# Rosefield Solar Farm

## Design Approach Document

(Tracked)

EN010158/APP/5.8.2  
Revision 2  
Deadline 1  
September 2025 March 2026  
Rosefield Energyfarm Limited

Figure 5.6: Illustrative Masterplan of the Proposed Development

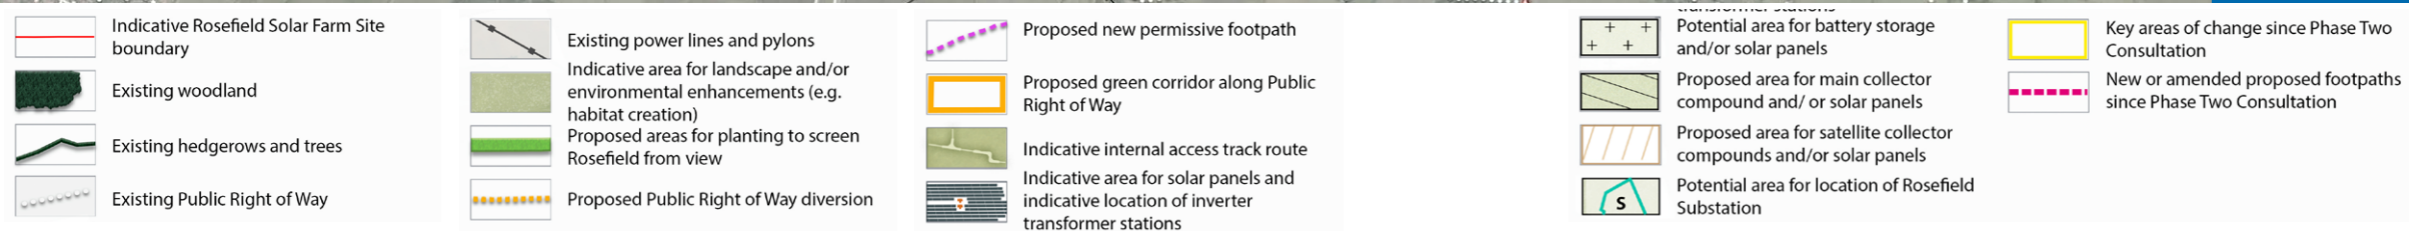
[\(Updated Figure\)](#)

Figure 6.20 Existing and Proposed PRow and Permissive Footpaths

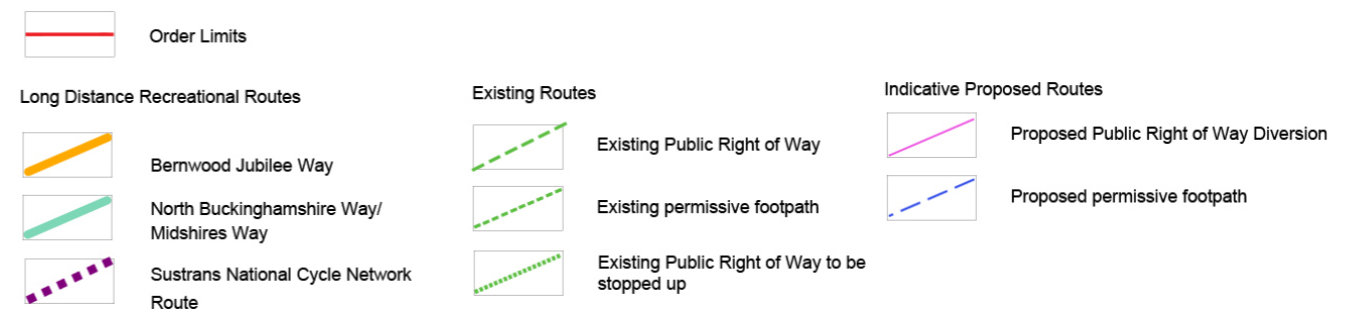
(Updated Figure)
